# Technical Memorandum

**Subject:** *989 Somerset Street Residential Development – Transportation Addendum No. 2, Rev. 1*

**Re: 989 Somerset Street**  
**TIA Addendum #2 – Response to City Comments**

Figure 1: Site Plan – October 2022

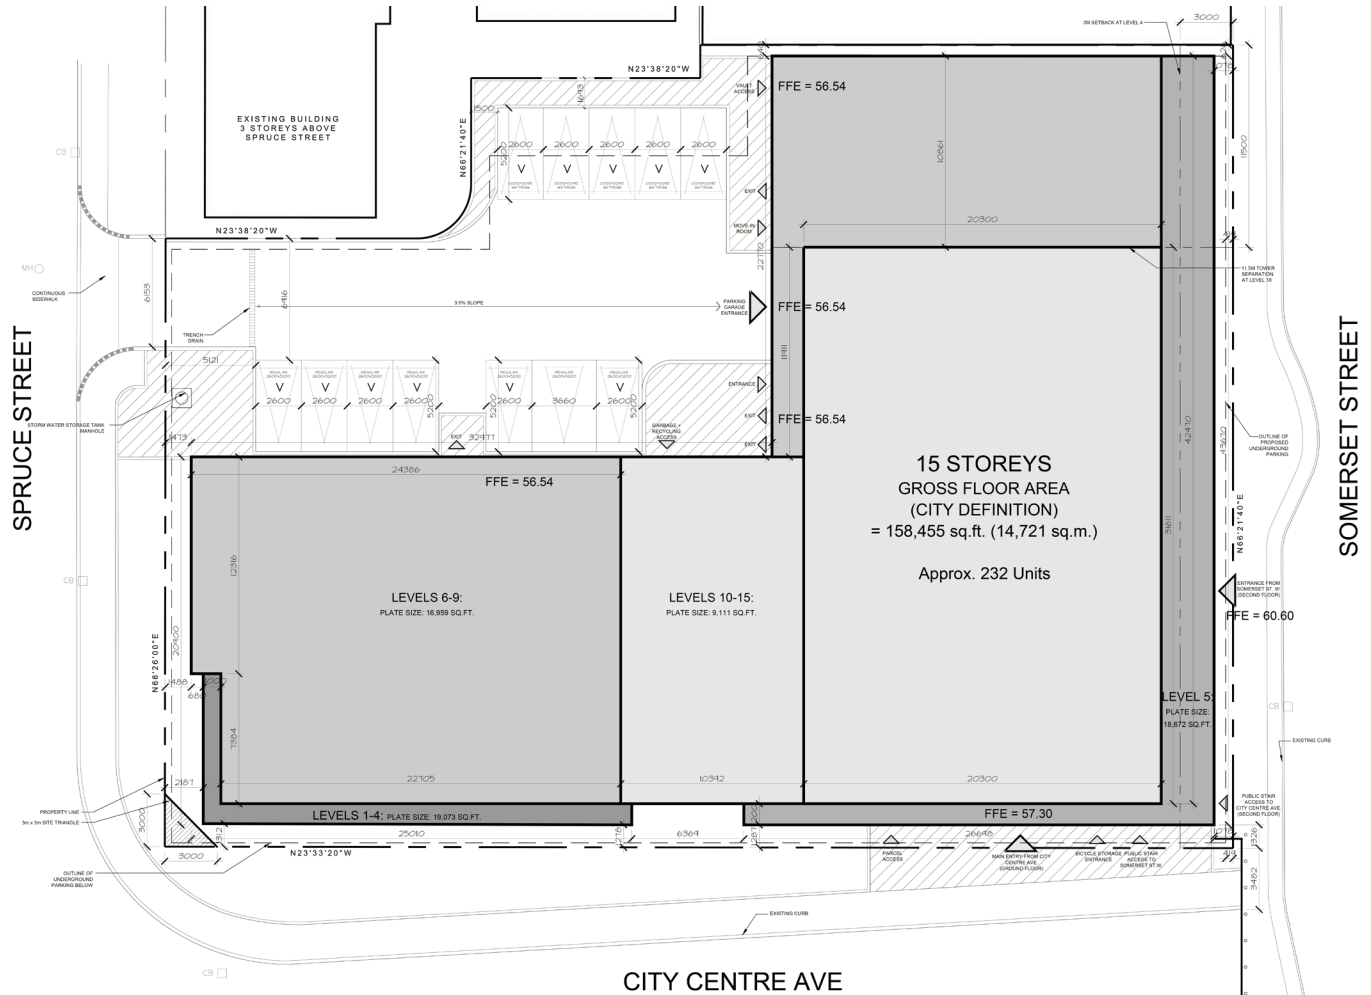
2. The site plan in Figure 1 lacks detail and is difficult to review. Please attach a detailed copy of the latest site plan to the Addendum for review. The site servicing and grading plan would also be helpful.  
New Site Plan as well as site servicing and grading plans provided as an attachment.

3. Figure 1 does not show a continuous concrete sidewalk on the south side of Spruce Street across the new access. Confirm new access will be constructed per City of Ottawa standard detail SC7.1. An attached site servicing and grading plan would help alleviate concerns.  
New Site Plan provided.

5. Provide more detail on the public stairs being provided between Somerset Street and City Centre Avenue (as indicated by Figure 1). These stairs were not discussed in the 2019 TIA Strategy. Ensure the stairs meet all requirements of the Section 2.3 of the City of Ottawa Accessibility Design Standard, including the provision of TWSIs per Section 2.3.1.3. The stairs are located outside, and are entirely inset into the building with the upper floors directly above the stairs. They are 100% located on private property. The rendering below illustrates its location (see bright red entrance to stairs at Somerset level). The stairs will be constructed according to the City of Ottawa Accessibility Design Standards, including TWSI installations.

**DRAWING TITLE:**  
SITE PLAN

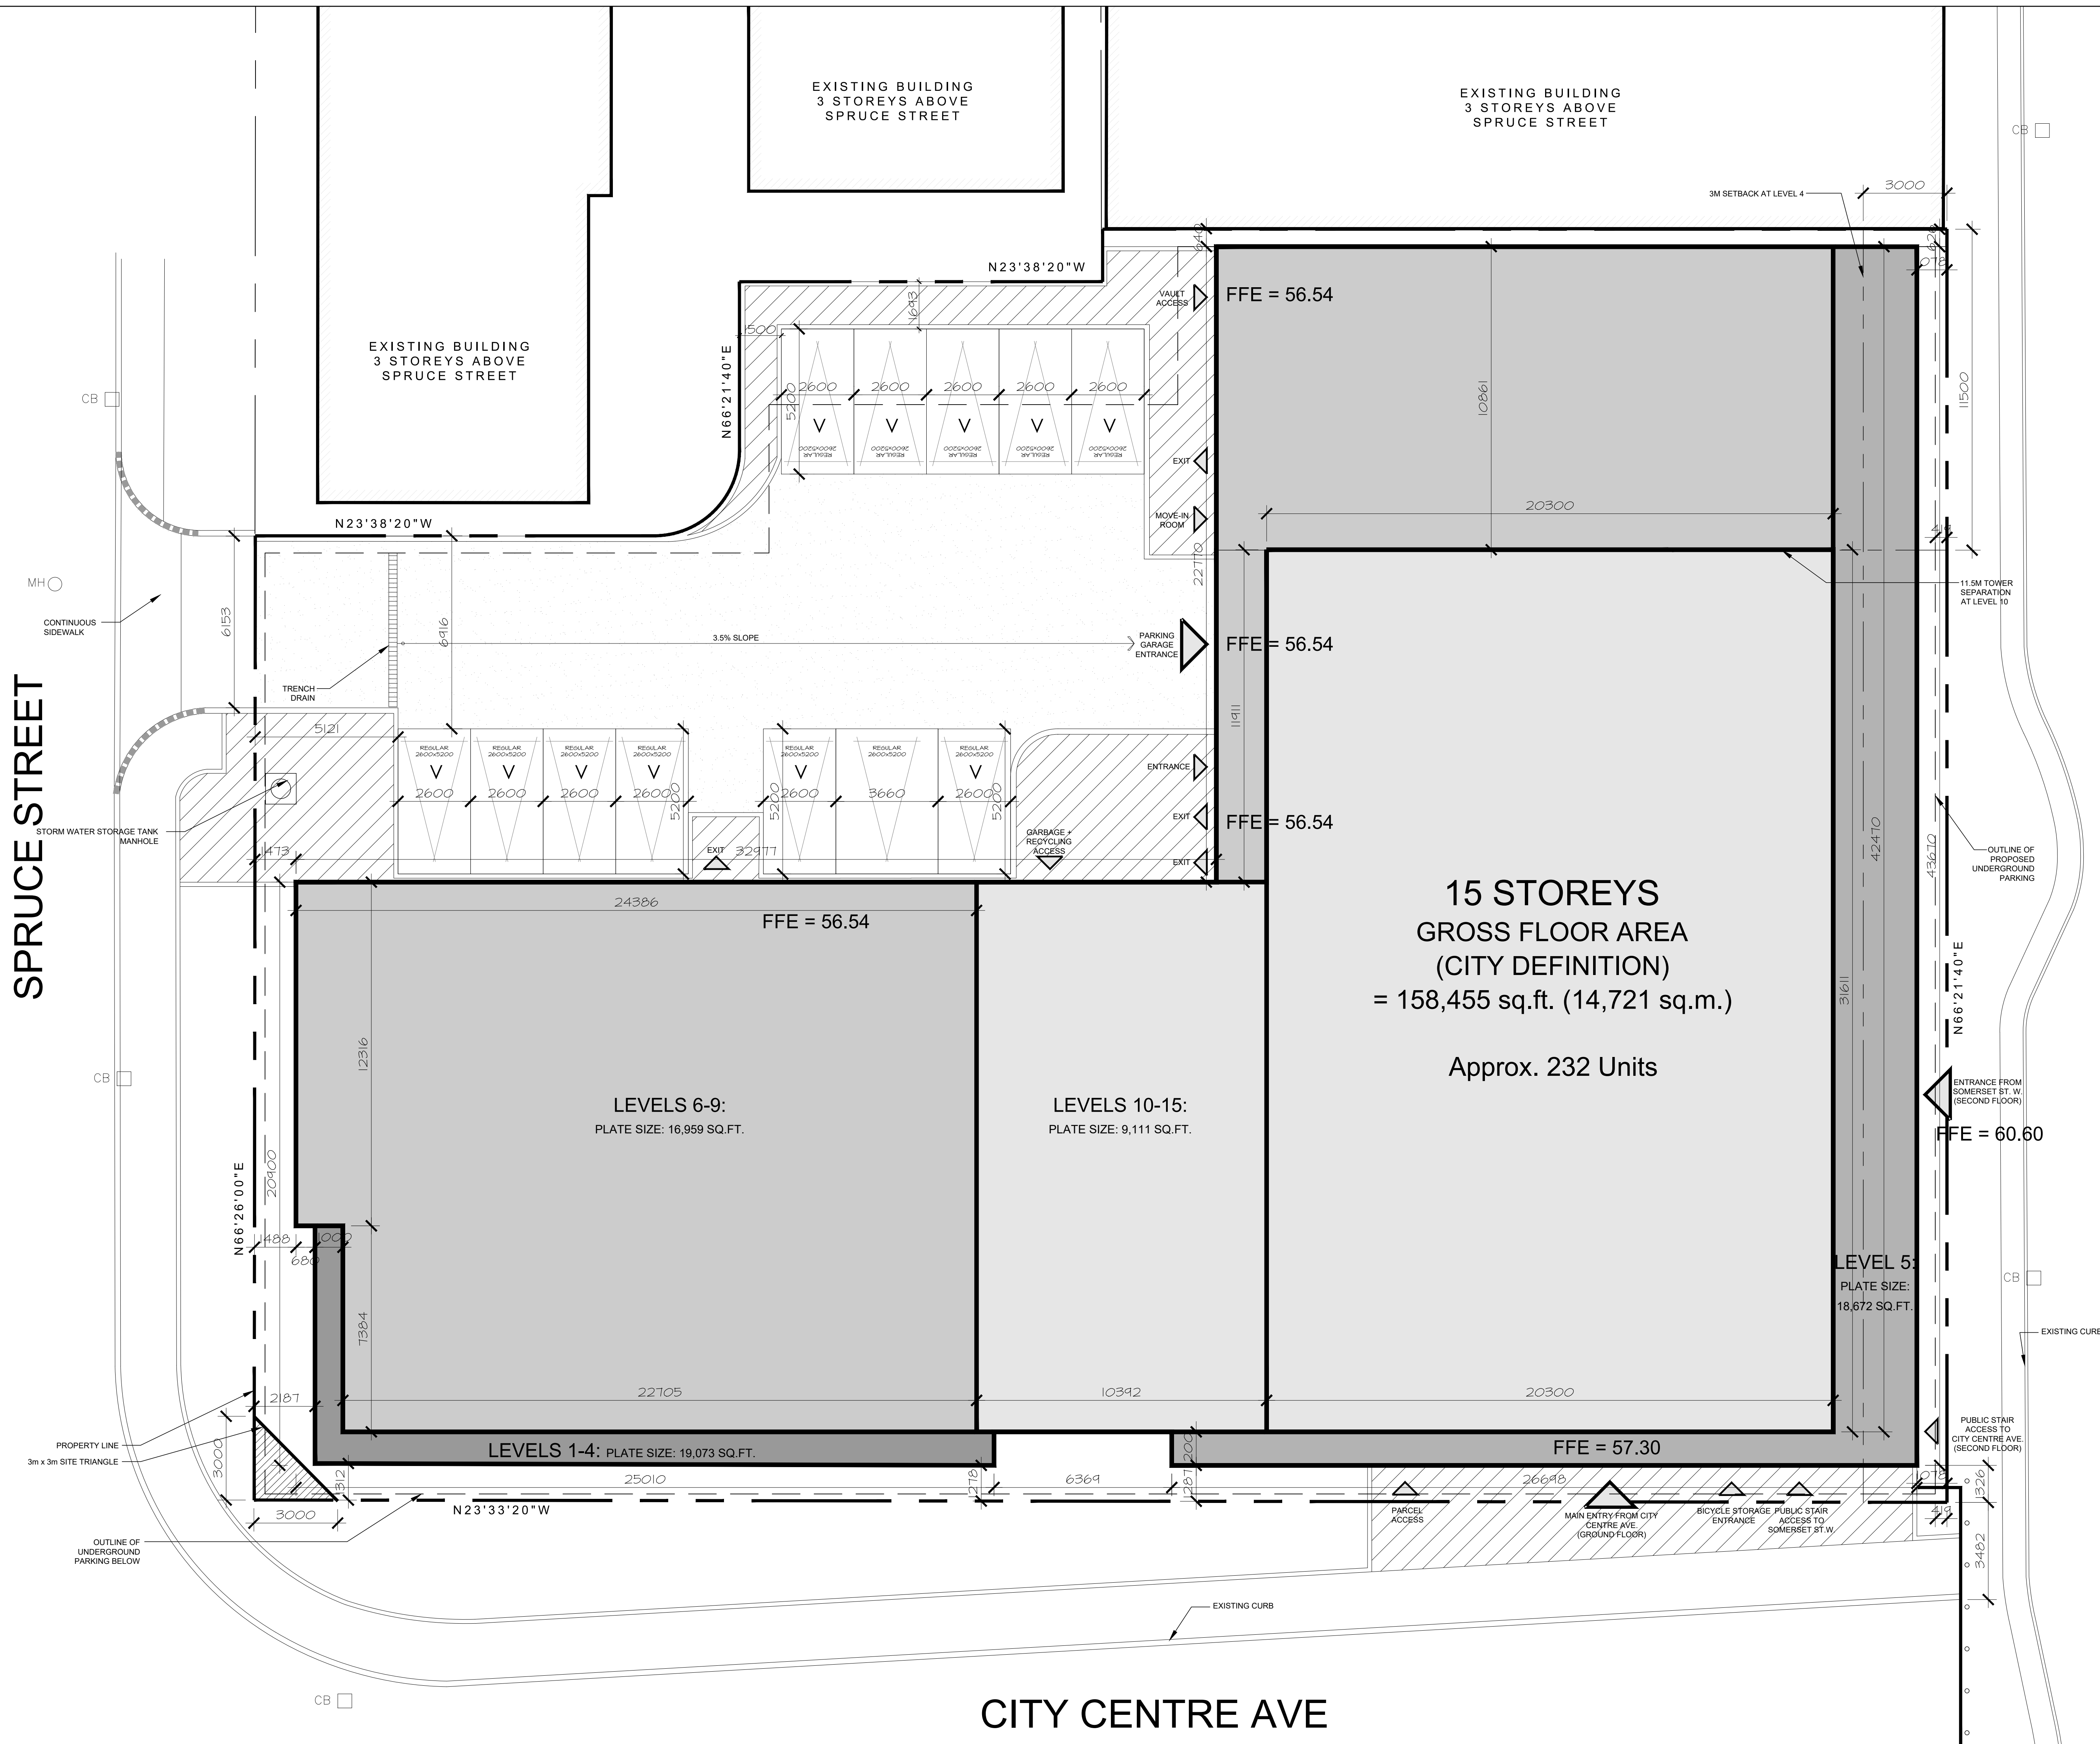
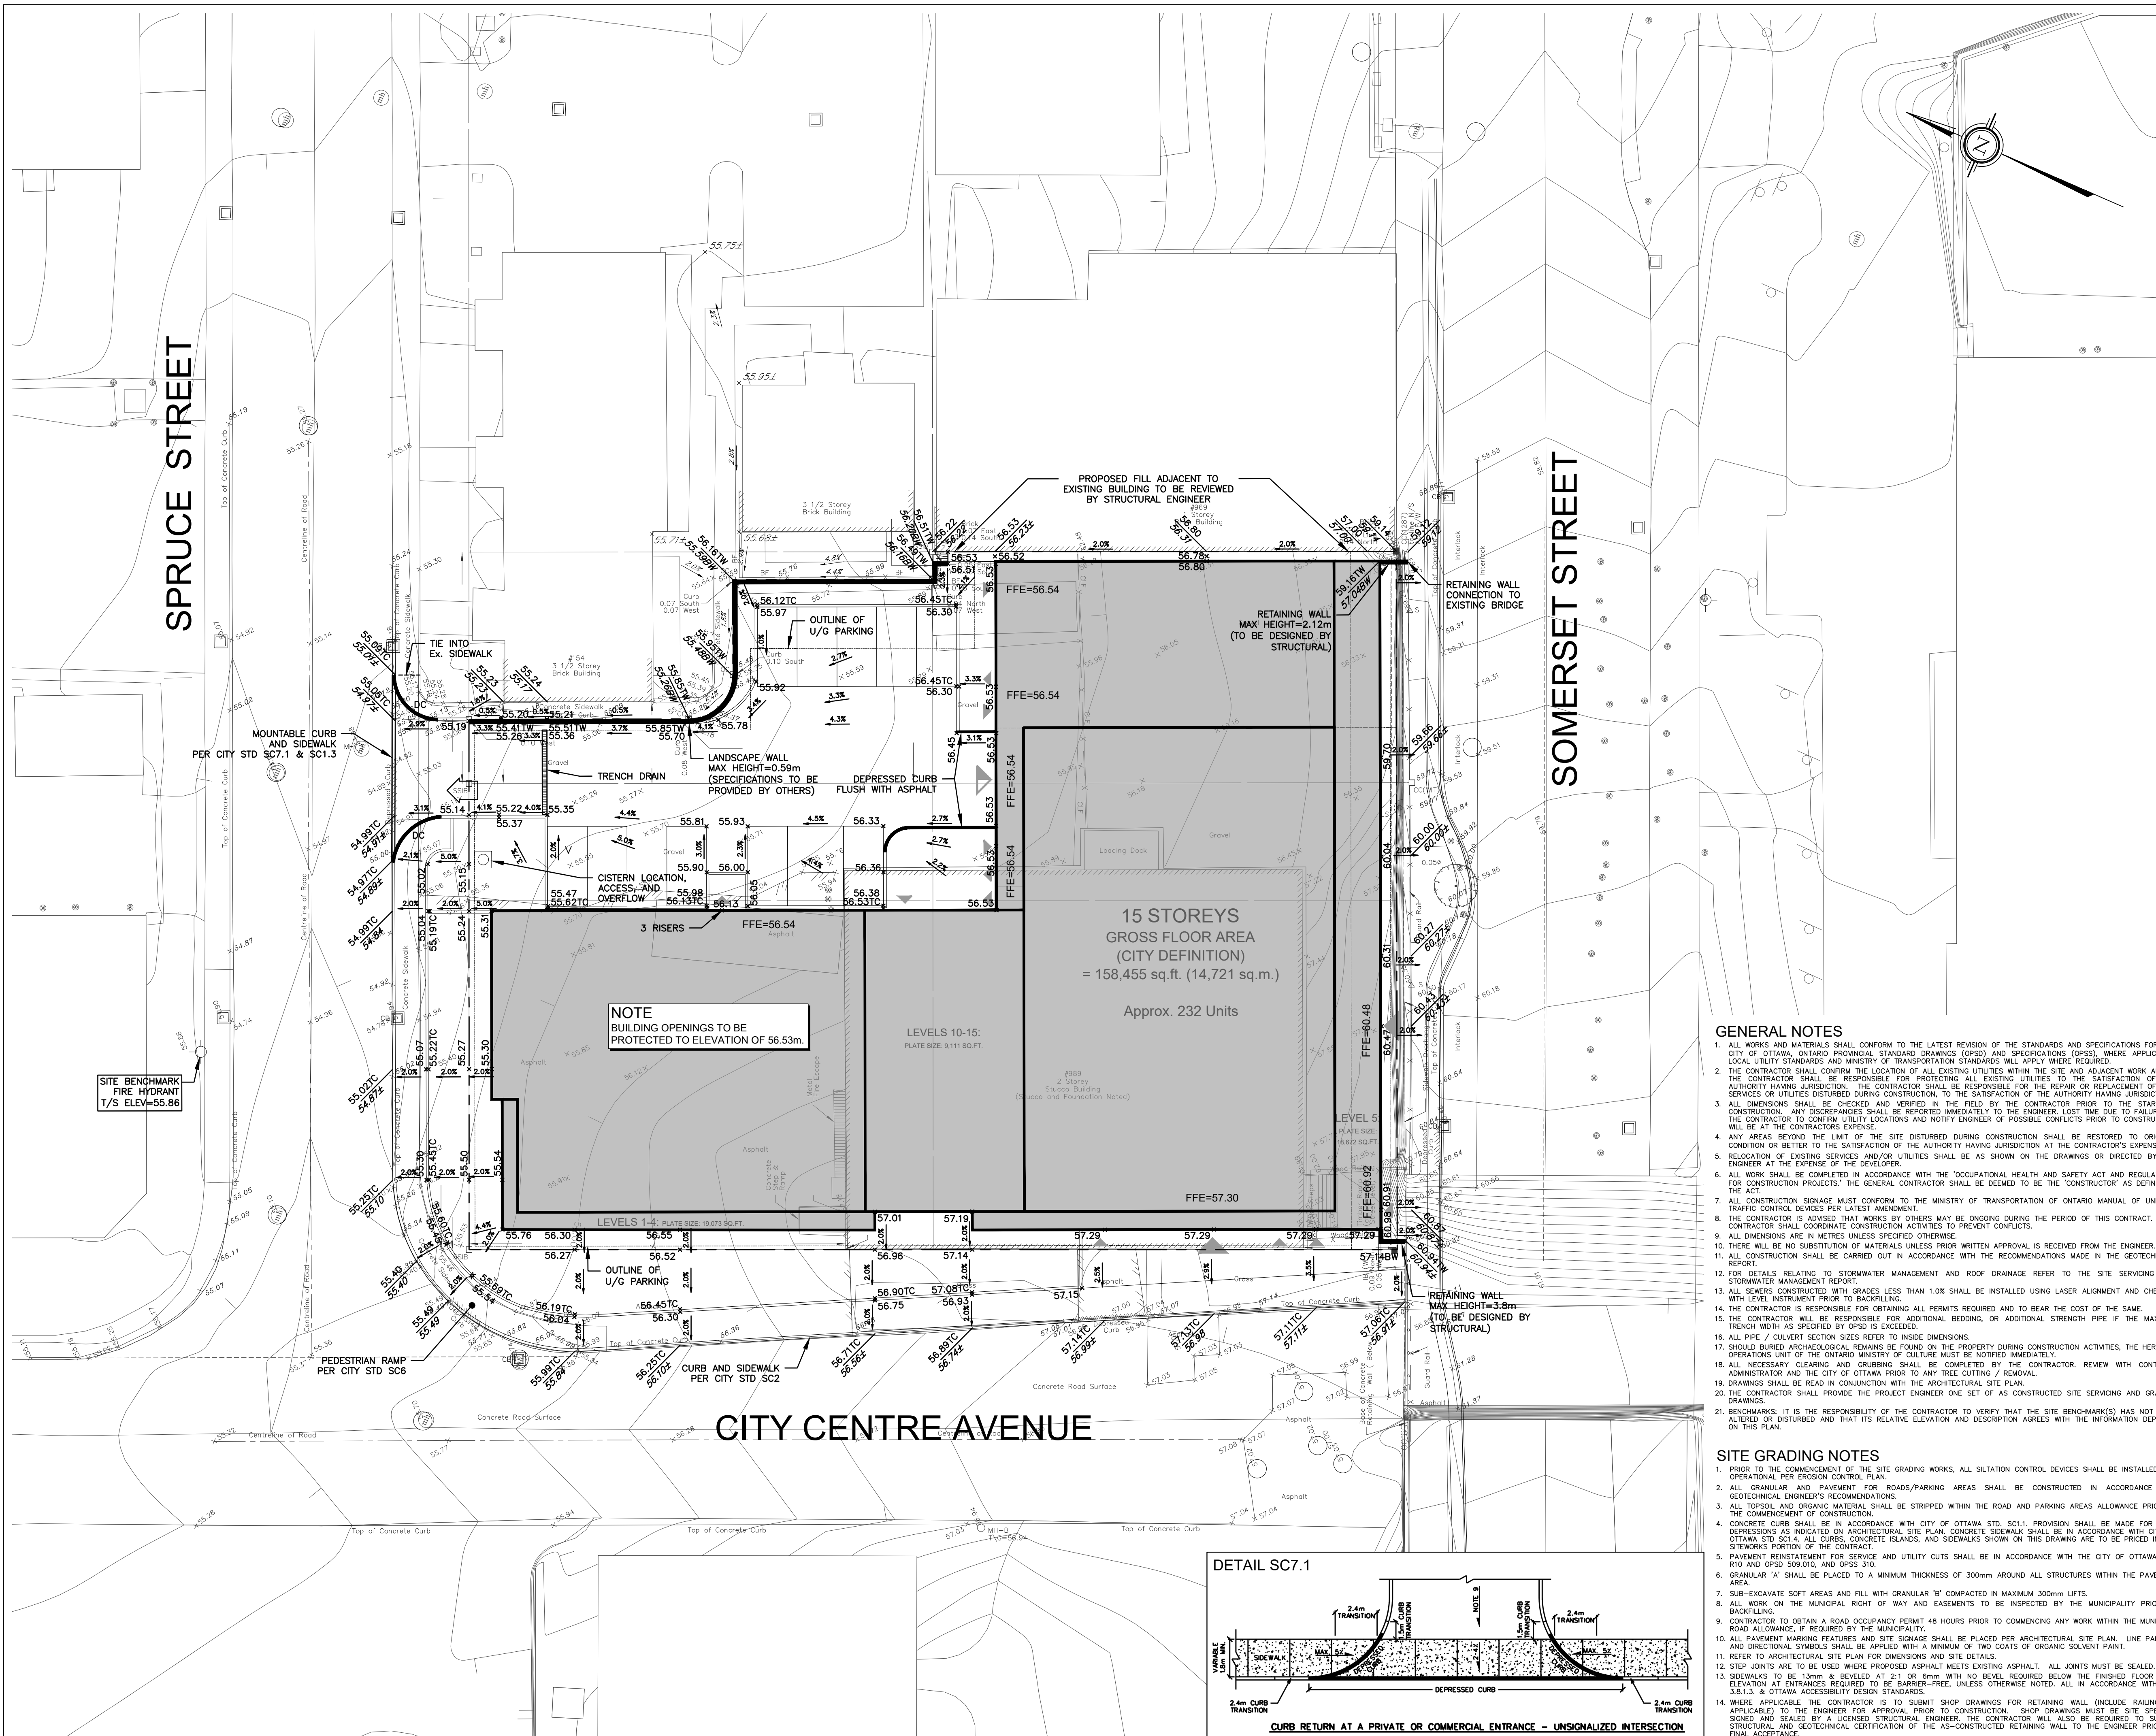
11. The segment MMLOS form indicates that sidewalk width on Spruce Street and City Centre Avenue (east side) is  $\geq 2$  m. However, previous site plans and site grading plans have shown 1.8m sidewalks in these locations. Please confirm sidewalk along the site frontage will be upgraded to a width of at least 2.0 m.  
*The proponent will provide 2-meter sidewalks for Spruce Street (south side) and City Centre Avenue (east side) adjacent to the site. This has been demonstrated on the site plan (See Appendix A)*
